SUBJECT: TECHNICAL BASIS FOR REVISED REGULATORY GUIDE 1.183
(DG-1199) FISSION PRODUCT FUEL-TO-CLADDING GAP INVENTORY

Proposed Revisions DG-1199

Revised Section 3.2

Figure 1 Maximum Allowable Power Operating Envelope for Non-LOCA Gap Fractions

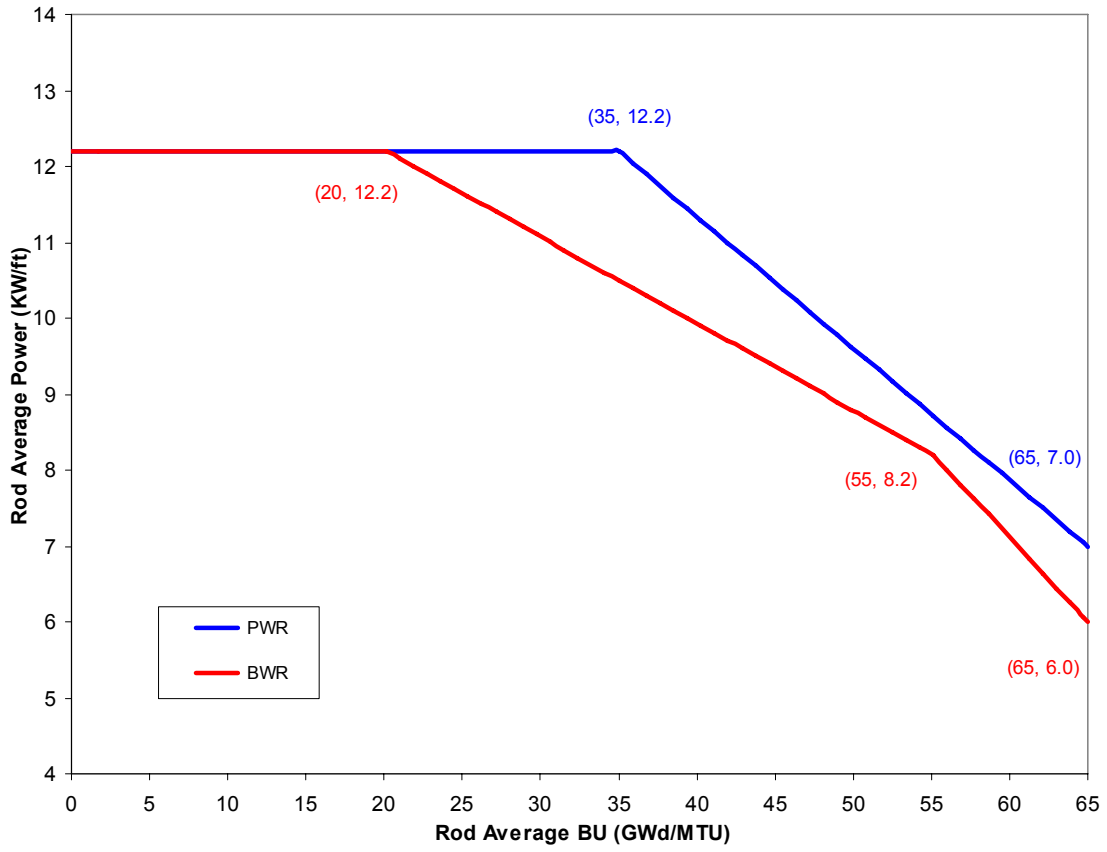
- In response to public comment, bounding fuel rod power profiles were extended. This necessitated a re-calculation of the fission product gap inventories. As part of this effort, peak nodal power (Fq) was replaced with rod average power (Fr) which is a better qualifier for fission gas release along the entire fuel stack and overall gap inventory.

The applicability of Table 3 non-LOCA fission product gap fractions is limited to fuel rods with a peak rod average power history below the bounding power envelope depicted in Figure 1. Appendix K provides an acceptable analytical technique for calculating non-LOCA fission product gap inventories based upon specific fuel rod designs or more realistic fuel rod power histories. Reference 18 documents the methods used to calculate the Table 3 and Table 4 fission product inventories, including application of modeling uncertainties.
